DOCUMENT 00911

ADDENDUM NUMBER 1

**Santa Rosa Aqueduct Seismic Hazard Mitigation
(Rodgers Creek Fault Crossing)**

FROM: Sonoma County Water Agency
404 Aviation Blvd.
Santa Rosa, CA 95403-9019

PLAN VIEW - NEW TURNOUT AT SOTOYOME ROAD
SCALE: 1"=20'

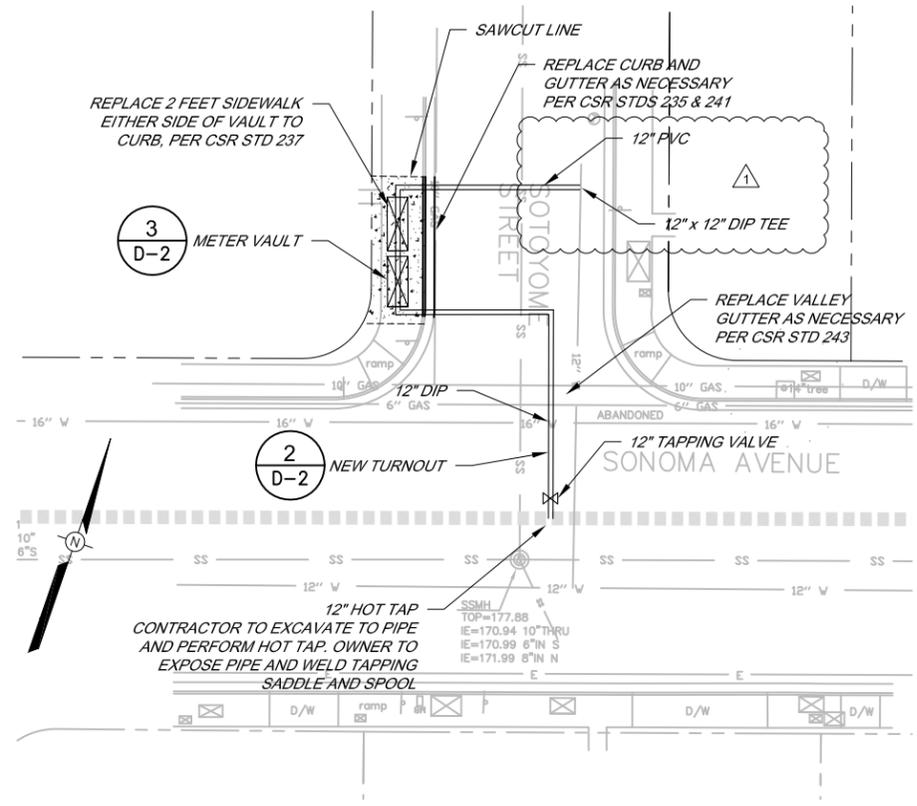
9. Plan Sheet C-5 Pipe Schedule references the bedding material requirements by the station; specifically station 4+95 and 21+70 the schedule require typical bedding materials but the plans indicate CLSM be placed in these areas. Clarify what plan we are to use during the bid process.

13. Please indicate the depth of the existing 36" WM at the tie in location and at the 12" cit in tee on Sotoyome Street. This work is shown on sheet C-5.

1. Can you please confirm to all bidders that the steel cylinder OD you are specifying for the new 36" pipe is 37.875" per the Pipe Schedule shown on Drawing C-5? There seems to be some confusion to the OD/ID of the new pipe because it is painted in & out.

Owner's response: Bid per Bidding Documents.

Owner's response: As-built drawings provided in the Bidding Documents. Reference Document 00320 (Geotechnical Data and Existing Conditions) and Owner's website: [Santa Rosa Aqueduct Seismic Hazard Mitigation \(Rodgers Creek Fault Crossing\)](#)

Owner's response: Answered in this Addendum above.

MAIN TRENCH PAVING DETAIL

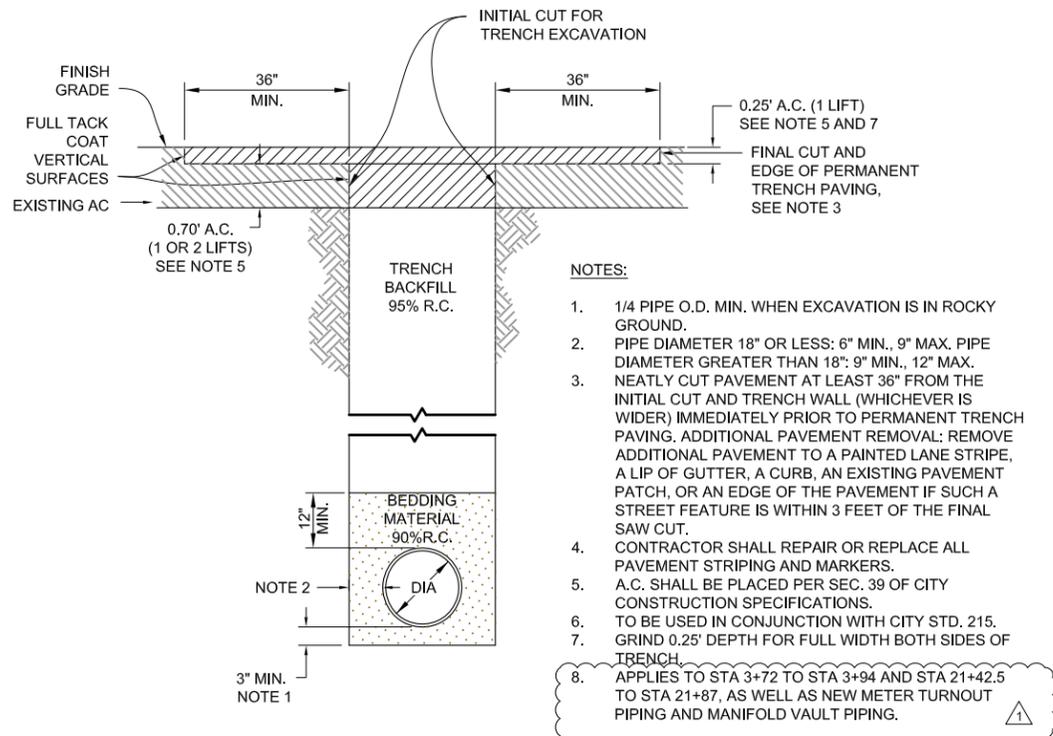
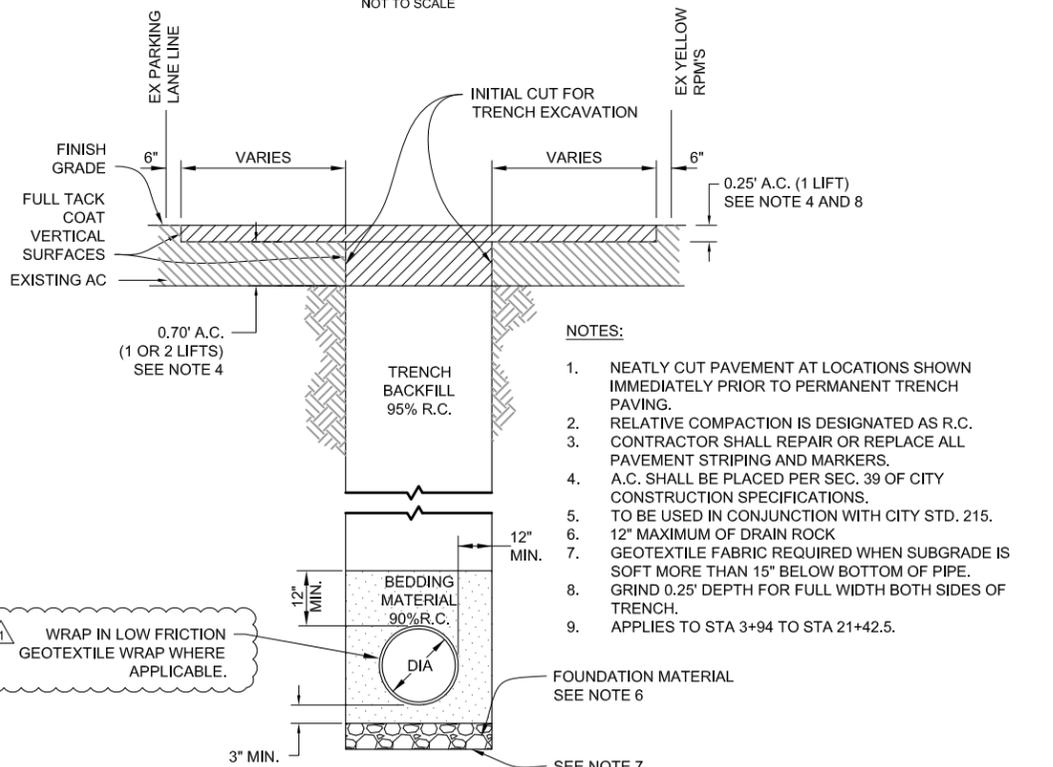
15. Please clarify the requirements for trench restoration for the work on Plan Sheet C-5 Sotoyome Street. The Trench details do not address this area.

16. Please provide a detail per section #15106 for the Low Friction Wrap around the pipeline. Details are missing in the Trench sections on plan sheet D-1.

Owner's response: Answered in this Addendum above.

Owner's response: Answered in this Addendum above.

BYPASS MANIFOLD DETAIL

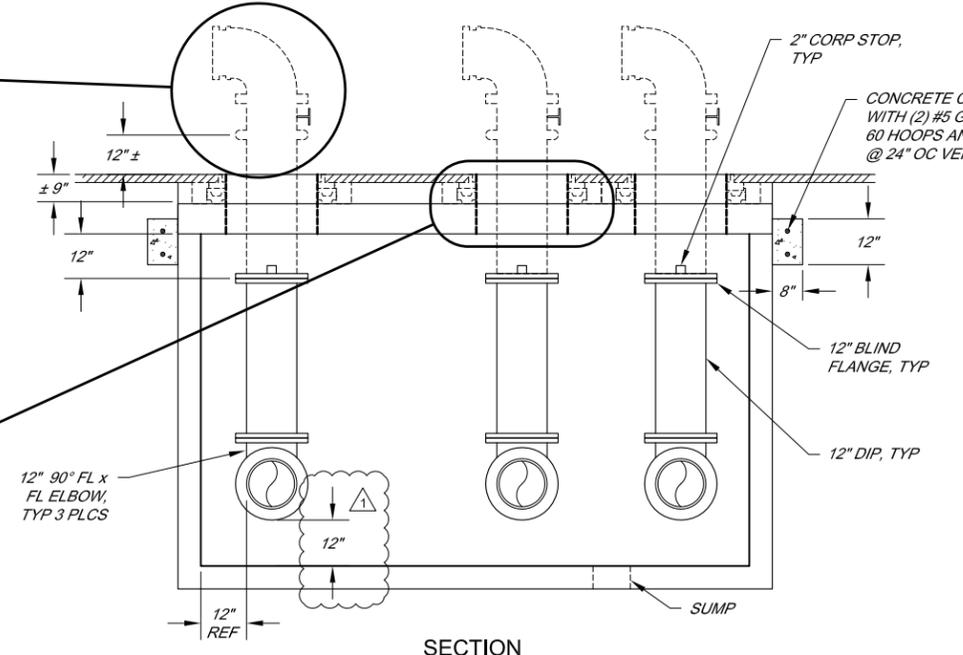
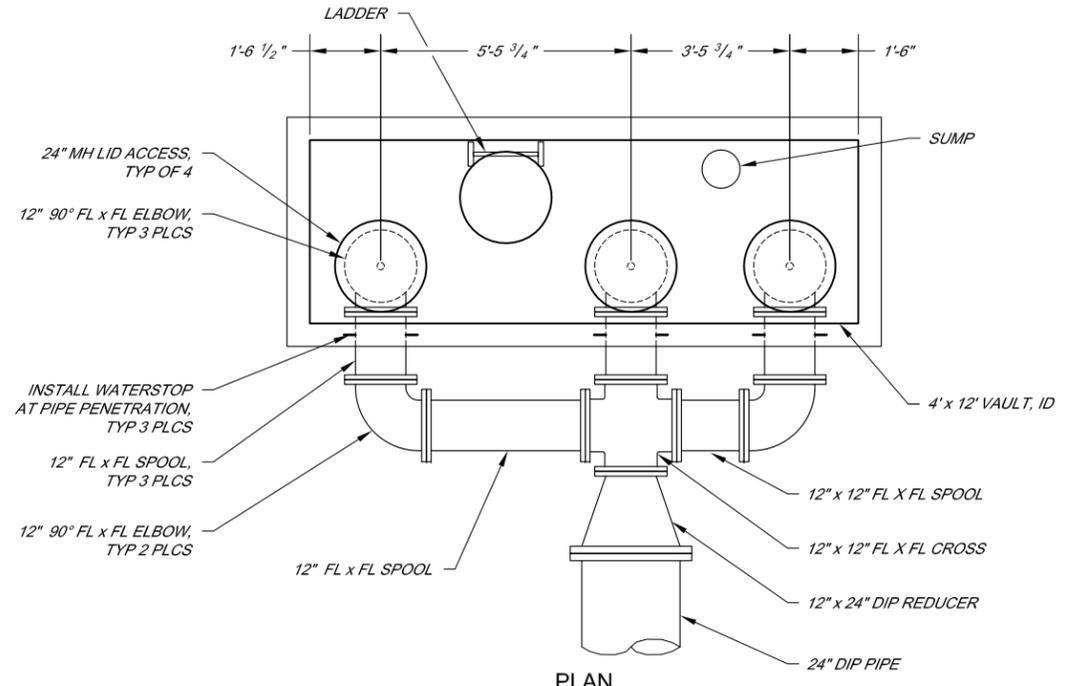
7. Plan Sheet D-1 By Pass Manifold Vault Structure and D-2 vault structures. Please clarify the depth of this structure since this detail is not to scale.

Owner's response: Answered in this Addendum above.

- NOTE**
1. PROVIDE VERTICAL AND LATERAL SUPPORT FOR MANIFOLD PIPING.
 2. CONTRACTOR TO COORDINATE REMAINING DIMENSIONS. DEPTH AS NECESSARY TO MAINTAIN MINIMUM COVER ON 24" DIP.

WATER METER INSTALLATION

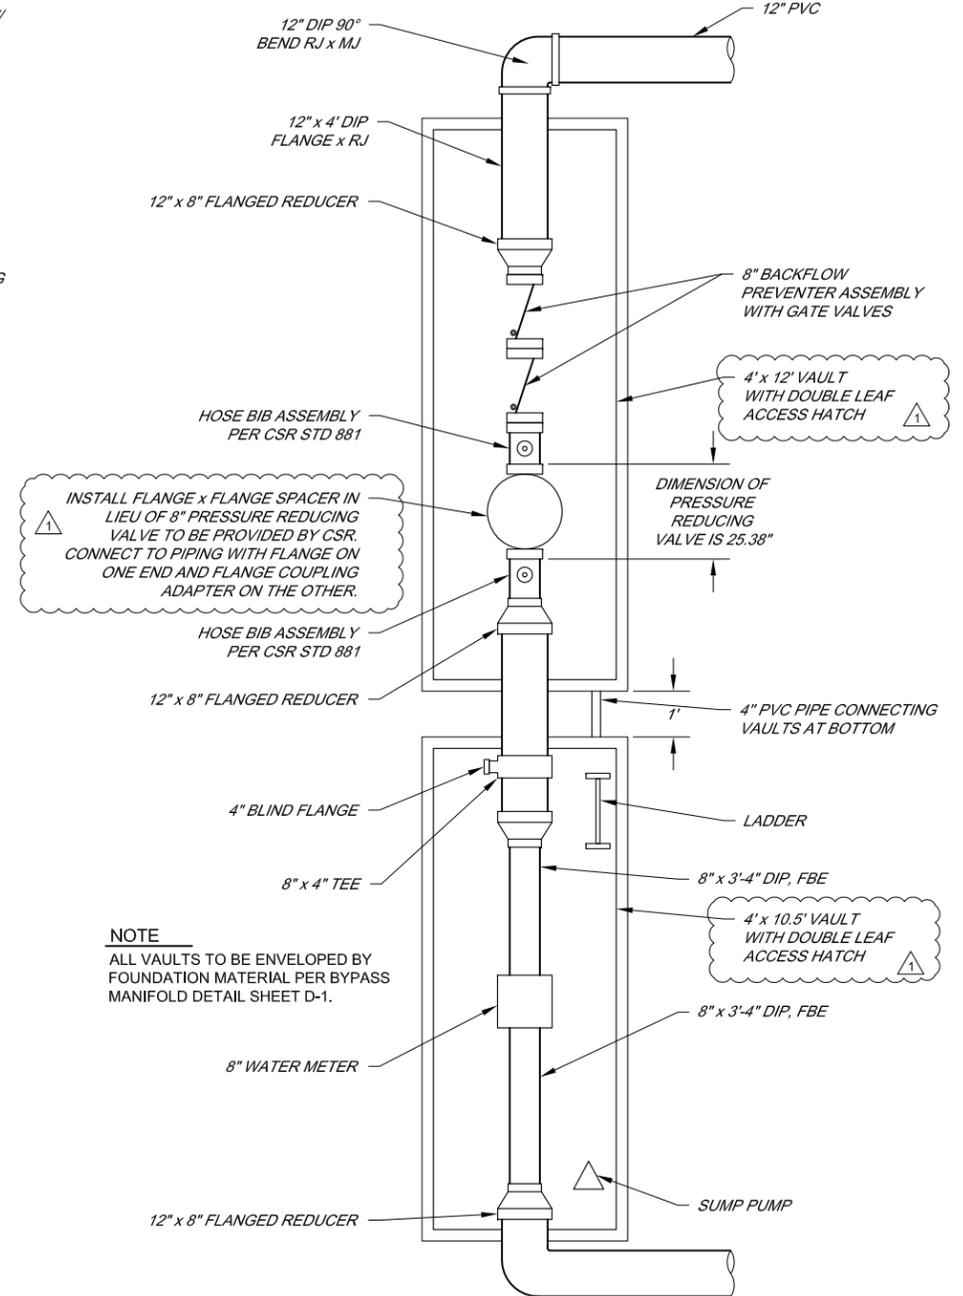
12. Plan Sheet D-2, detail 3; Water Meter Installation; Please provide the following information;
 - a). Vault lid details (none shown)
 - b). Vault depth including profile view.

c). Note on detail states to provide space in lieu of PRV to be provided by CSR. Who is CSR and will this agency install the unit?

Owner's response: Answered in this Addendum above.

- DEPTH AS NECESSARY TO MAINTAIN MINIMUM COVER ON 12" DIP.
- PROVIDE VERTICAL AND LATERAL SUPPORTS FOR PIPELINE.
- CONTRACTOR TO COORDINATE REMAINING DIMENSIONS.
